PUBLIC COMMENTS ON THE PETROCHEM PLANNED DEVELOPMENT PERMIT PROJECT AND PLANNING DIVISION STAFF'S RESPONSE TO PUBLIC COMMENTS, PL16-0118

County of Ventura
Planning Director Hearing
PL16-0118

Exhibit 9 - Public Comments and Response to Public Comments

**Figure 3-1
Ojai Planning Area**

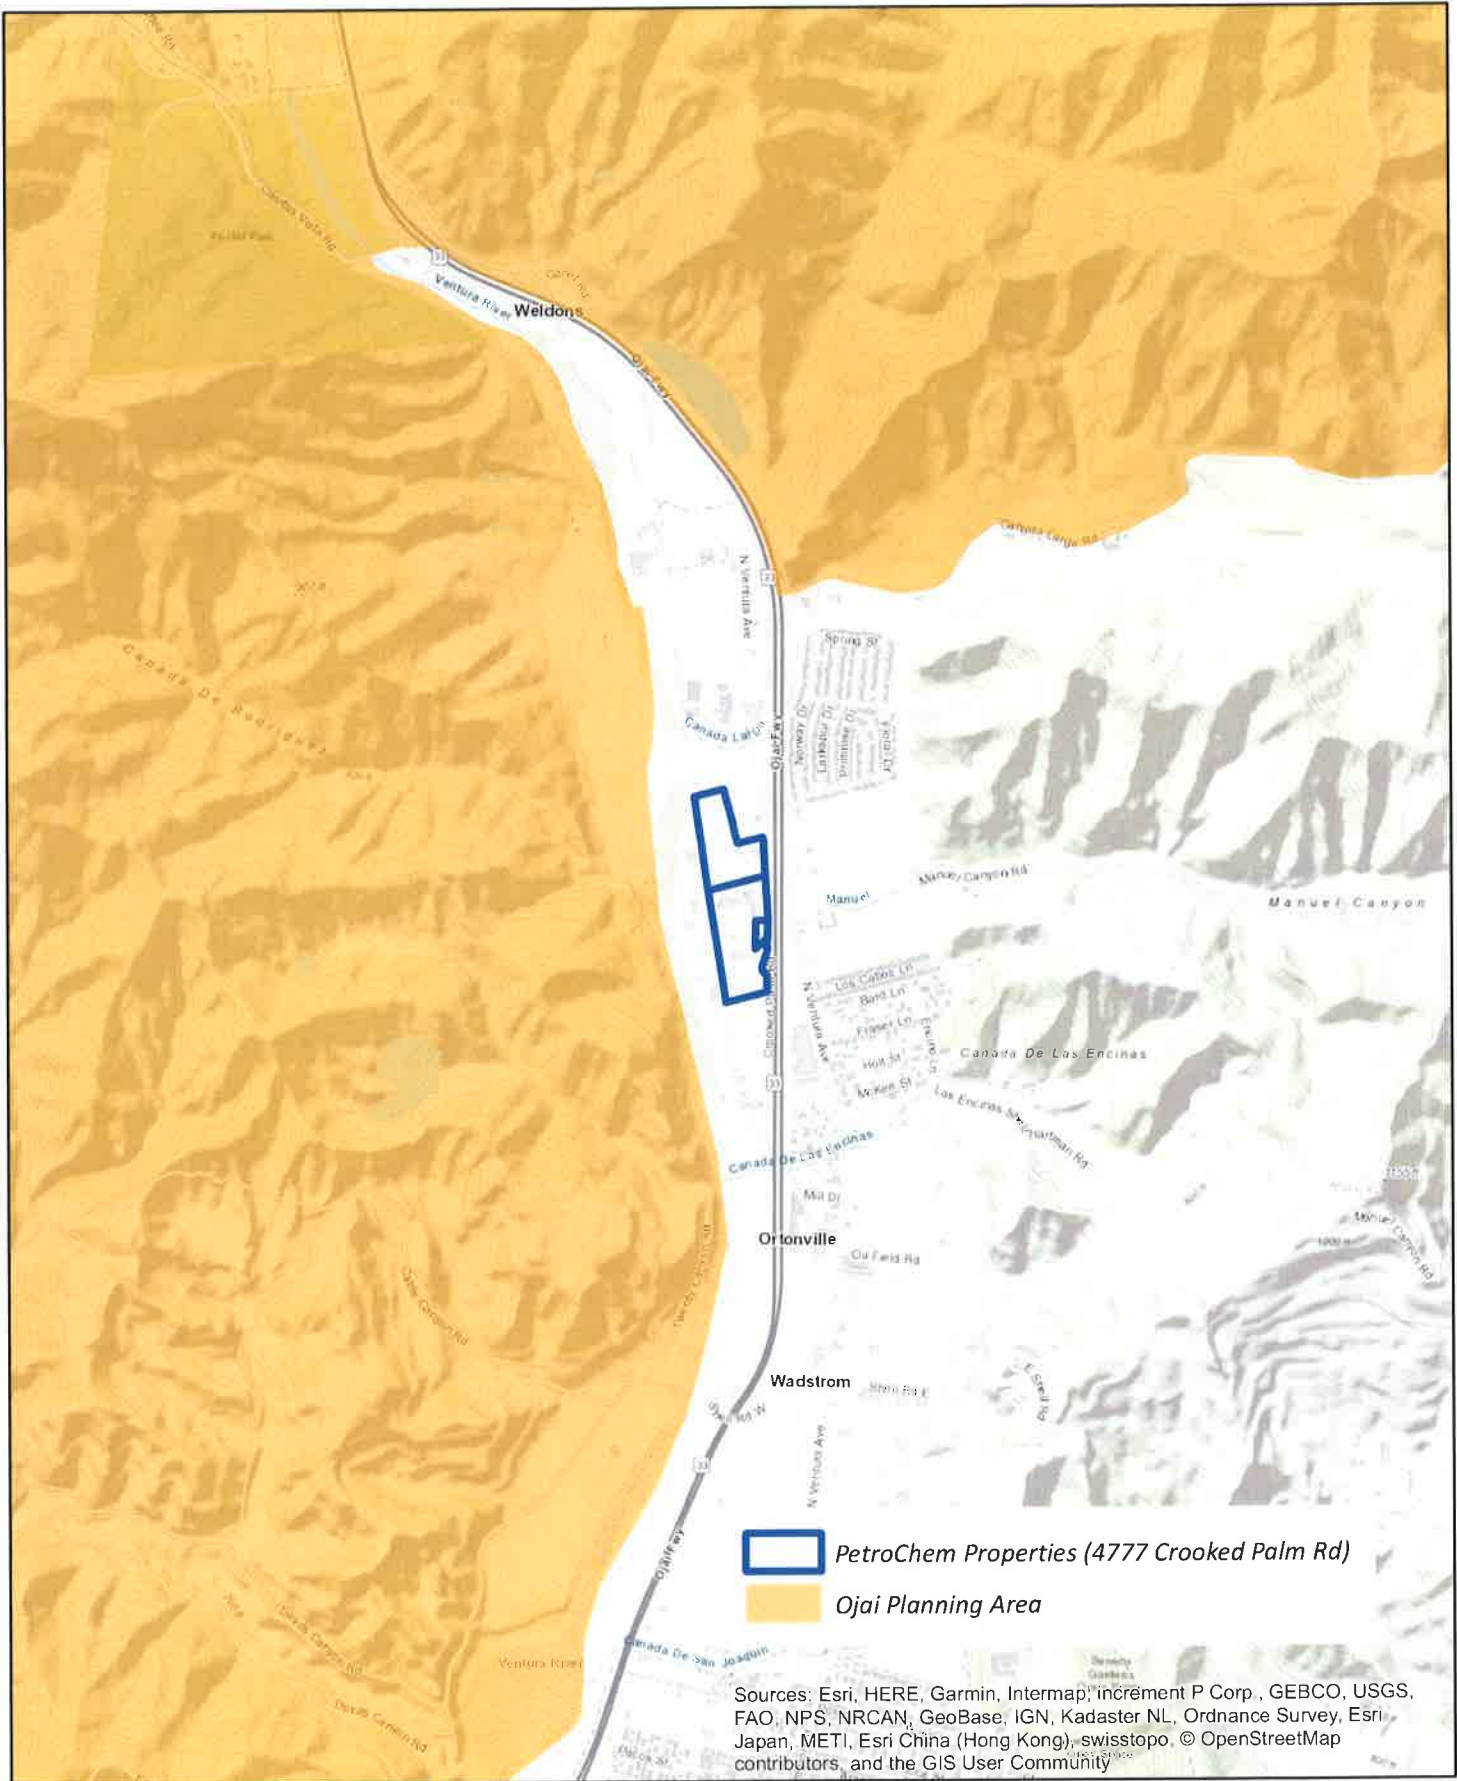
For purposes of air quality evaluation, the MND uses the Ventura County air emissions threshold of 25 pounds of ROC/NOx per day. However the project location is within the Ojai Valley airshed/Planning Area, and is therefore subject to the 5 lb-per-day threshold of significance for ROC/NOx.

*The Ojai Planning Area is the area defined as the "Ojai Valley" in Ventura County Non-Coastal Zoning Ordinance, Article 12, Section 8112-2, plus the Ventura (Ojai) Non-growth Area (NGA) (as depicted in the 1987 Ventura County Air Quality Management Plan (AQMP), Appendix E-87, Figure E-1, "Map of Ventura County with Growth/Nongrowth Areas," page E-11). In these Guidelines, see Figure 3-1, "Ojai Planning Area."

NOx emissions are likely at least 7.19 pounds per day which clearly exceed the Ojai Valley Planning

Area threshold of significance of 5 lbs. NOx per day. The air quality assessment in the MND must be re-evaluated in order to be consistent with the VCAPCD Guidelines and the Ojai Valley Planning Area thresholds of significance. The re-evaluation must include a detailed explanation of what emission sources were included in the NOx calculation and what method was used to determine the total.

The definition for "Ojai Valley" identifies the Ojai Valley as depicted on AQMP Figure E-1. Figure E-1 is not very clear with regards to the Growth Area and its proximity to the project site. The GIS exhibit provides a more clear depiction of the project site and shows it is not in the "Ojai Valley Planning Area," and thus not subject to the 5 pounds per day threshold of NOx and ROC emissions.

Exhibit 9, Attachment 1- Ojai Planning Area information

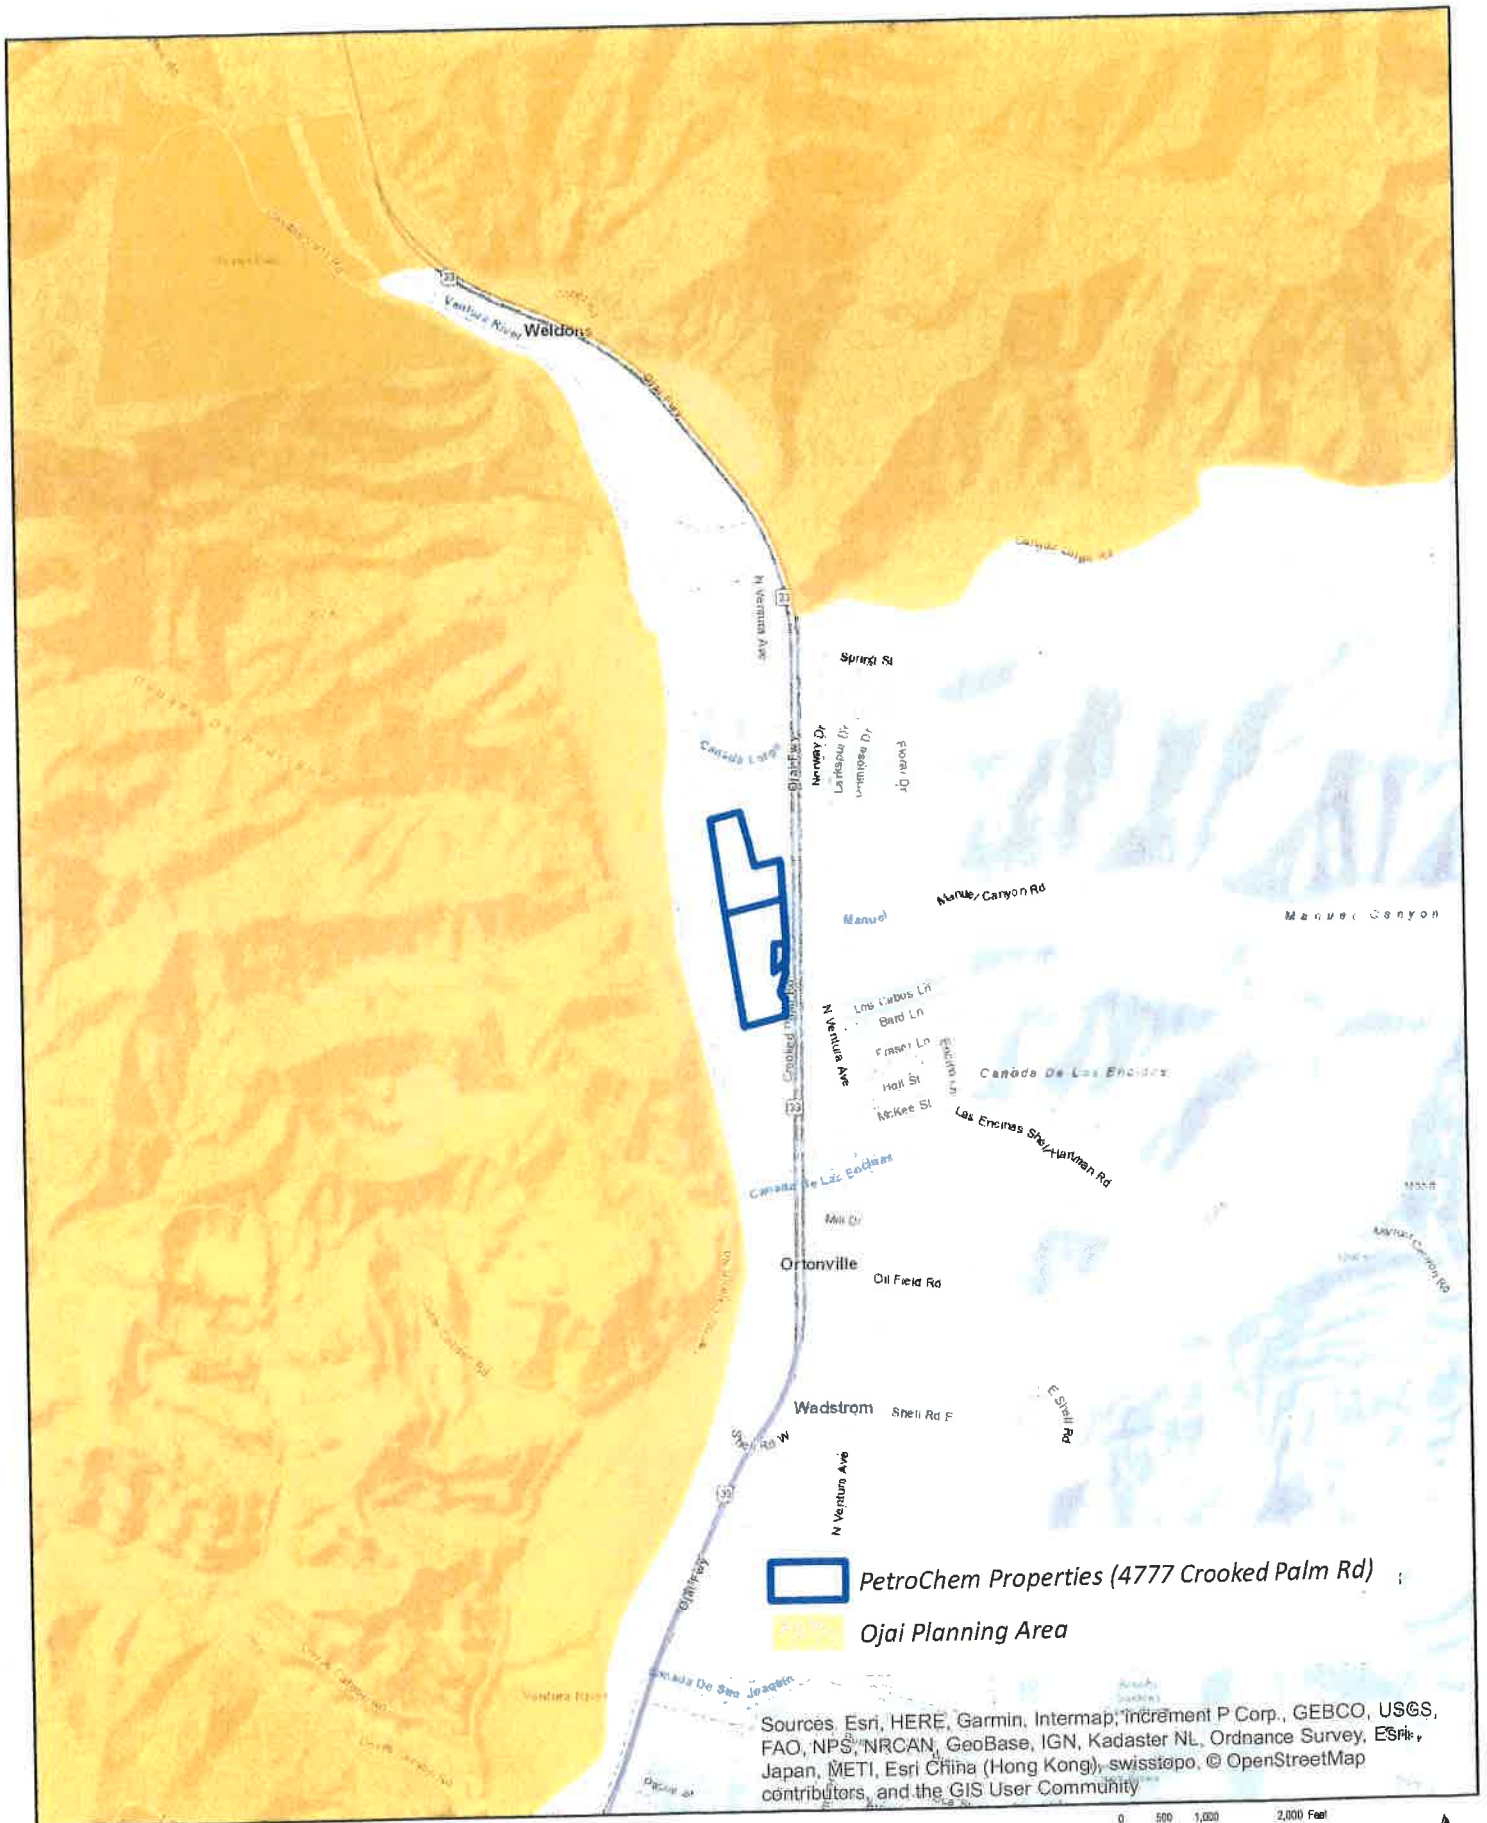
- Non-Coastal Zoning Ordinance Article 12, Section 8112-2 – Definitions.
- Figure E-1 from the Air Quality Management Plan (AQMP) (1987)
- An exhibit prepared by County GIS that is more accurate than Figure E-1 noted above
